## INFORMATION REQUEST FOR DA/764/2014 – ALTS & ADDS TO EXISTING SHOPPING CENTRE

Council comments relating to Landscape with Sym.Studio response below.

Figure 1 – Extents of 'Core Area'

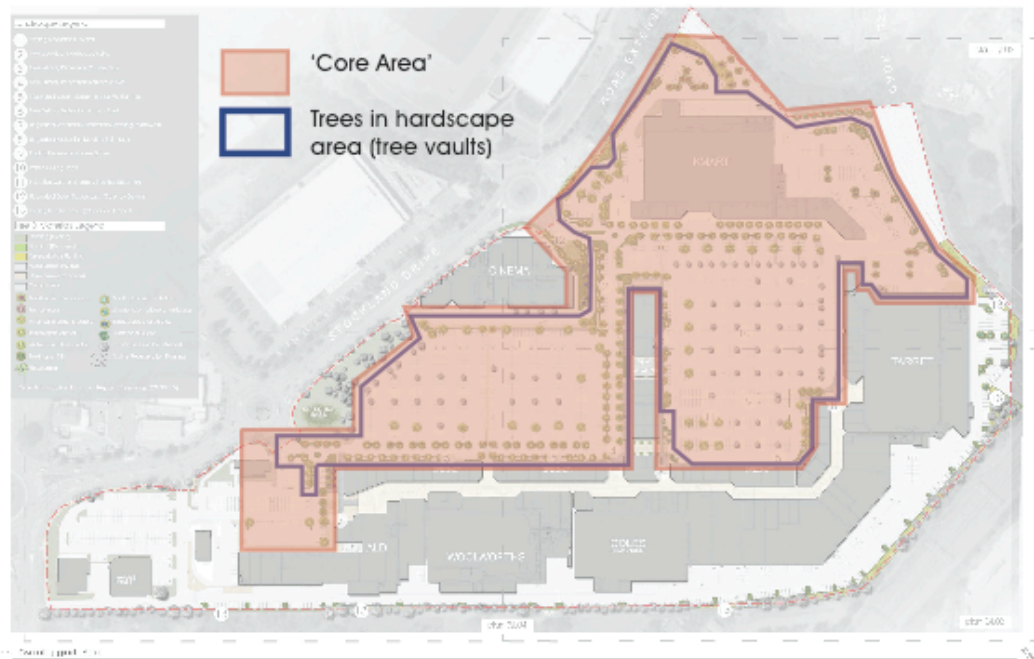
1. The Preliminary Arborist Report condemned all existing soil cell structure to existing car park shade trees. The arborist states that majority of existing trees central to the carpark ascertain girdling roots with many trees having a Useful Life Expectancy (ULE) of less than 5 years. The recent landscape plans nominate these trees for retention rather than replacement and as per Arborist advice an improved soil cell structure to ensure establishment and growth opportunities is required.

Sym response: The location of proposed trees prioritise the sleeving of proposed and existing building frontages to enhance pedestrian comfort and quality of outdoor experience. Table 1 below demonstrates that the proposed scheme will result in 71 additional trees within the 'Core Area'.

The intervention of additional trees has taken advantage of the road reconstruction wherever possible. Since there is no proposed change internal to the core parking areas - the disruption caused by these isolated (islands) of work would cause unnecessary disruption and impact to the temporary traffic management measures required for construction.

Furthermore the existing trees in carpark trees (identified by arborist) do not pose a safety concern – their potential upgrade will come under the ongoing maintenance regime as required.

# Tree numbers refer to core area only. Extent of core area shown in Figure 1 below.
